PRODUCT CHANGE NOTIFICATION COVERSHEET

CTS Part Number: Model 407

Product Description: Surface Mount Crystal

Reason for PCN: Change notification for revised product marking format.

Marking Information

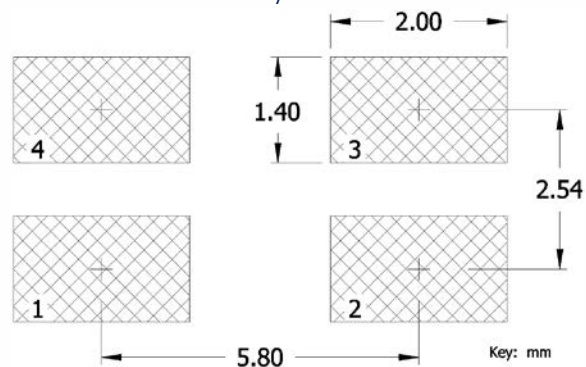
Description for Change: Change To - New Format

1. ** – Manufacturing Site Code.
2. YYWW – Date Code; YY = year, WW = week.
3. xxxx – Frequency Code.
3-digits, frequencies below 100MHz
4-digits, frequencies 100MHz or greater
[See document 016-1454-0, Frequency Code Tables.]

Change From - Old Format

1. XX.XXX – Frequency marked with 3 significant digits after the decimal.
2. C – CTS identifier.
3. ** – Manufacturing Site code.
4. YWW – Date Code, Y – Last Digit of Year, WW – Week.

1. ** – Manufacturing Site Code.
2. YYWW – Date Code; YY = year, WW = week.
3. xxx – Frequency Code.
3-digits, frequencies below 100MHz
4-digits, frequencies 100MHz or greater
[See document 016-1454-0, Frequency Code Tables.]
